## SERVICE BULLETIN

**APPLICABILITY:** 2019-21MY Forester

**NUMBER:** 07-202-23

**SUBJECT:** Headlight Water Intrusion / Design Changes

#### AREAS OF DESIGN CHANGE

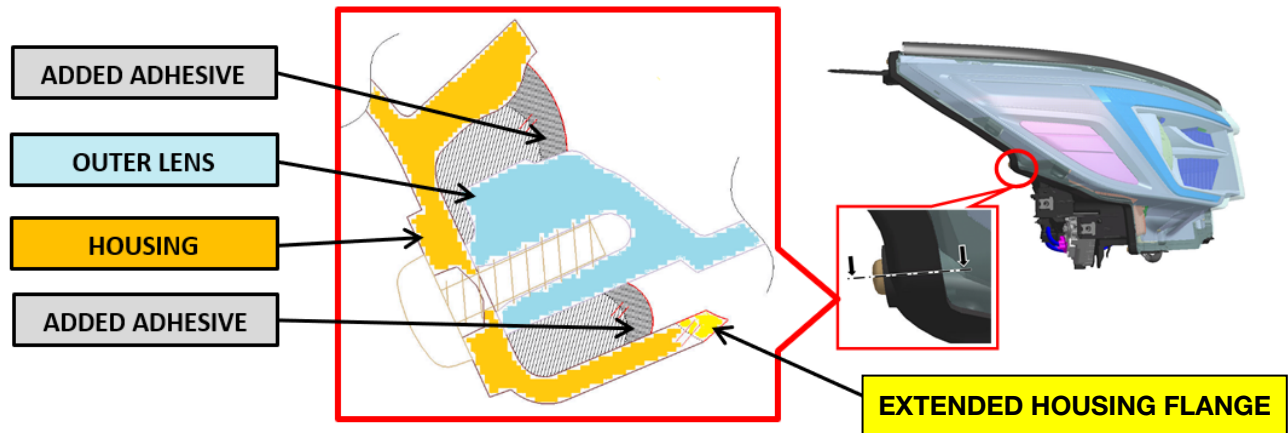
This bulletin announces the design changes to the headlights. The new assemblies are fitted with an extended flange on the housing along with an increased amount of adhesive added to provide optimum sealing. These changes reduce the chance of moisture entering the headlights. The headlight(s) should be replaced if water intrusion is found.
